**From:** [Chris Carr](#)  
**To:** [Warnock, George MEM:EX](#)  
**Cc:** [Beattie, Brent C MEM:EX](#); [Narynski, Heather M MEM:EX](#); [Demchuk, Tania MEM:EX](#)  
**Subject:** RE: Draft OMS Manual [M-200 Permit - Approving the TSF Breach Repair and Perimeter Embankment Buttress Design for 2015 Embankment]  
**Date:** Tuesday, April 14, 2015 4:30:17 PM  
**Attachments:** [image001.png](#)

I have reviewed the draft OMS manual submitted by MPMC. The document includes the major components of an OMS as suggested by MAC in “Developing an Operation, Maintenance and Surveillance Manual for Tailings and Water Management Facilities”.

**Review and Comment on  
Mount Polley Mine Re-Opening Application and Water Management Plan, 20 March 2015**

# Panel - Stage 6B Geometry

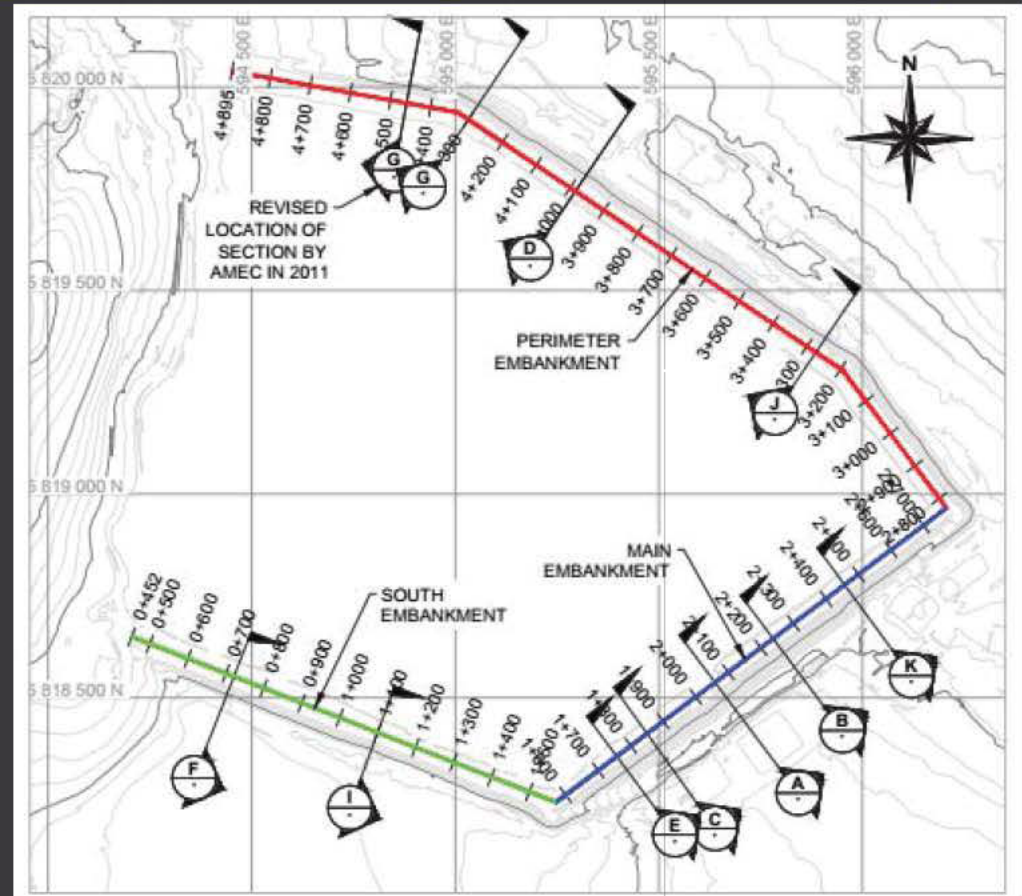
- Panel extrapolated geometry from Section 1/Plane D at Ch. 39+86 instead of Plane G at Ch. 43+00
- Panel assumed angle of repose embankment slopes incorporated in Stage 6 and subsequent stages

# Panel Stability Section vs Stage 6B As-Built

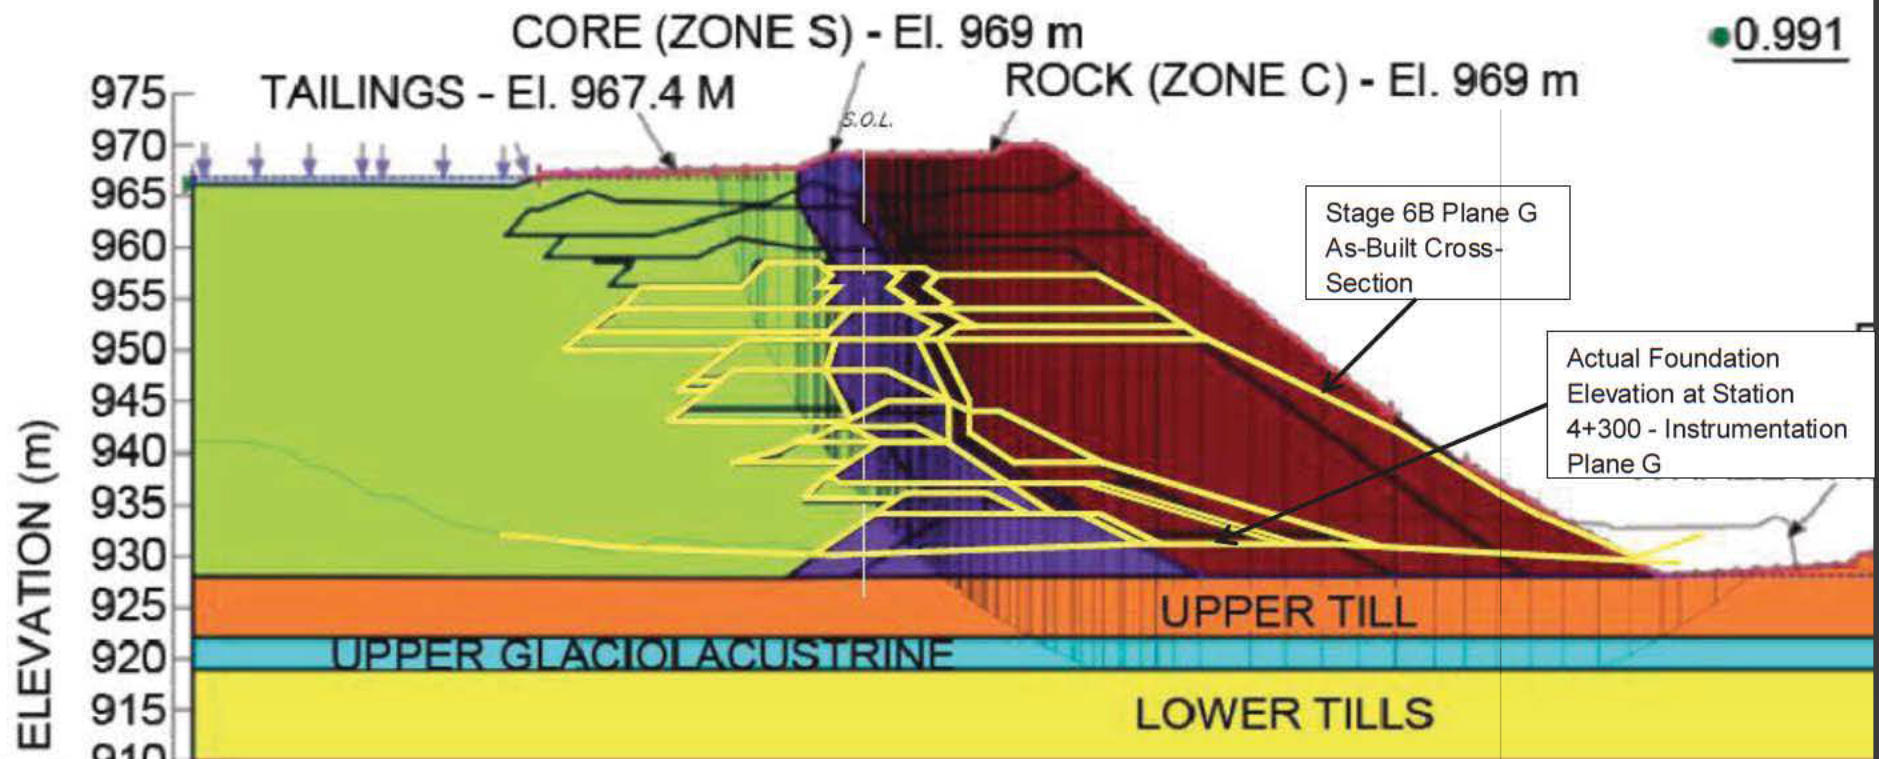
- Yellow outline shows actual geometry superimposed on Panel geometry
- Internal staging used by Panel is incorrect
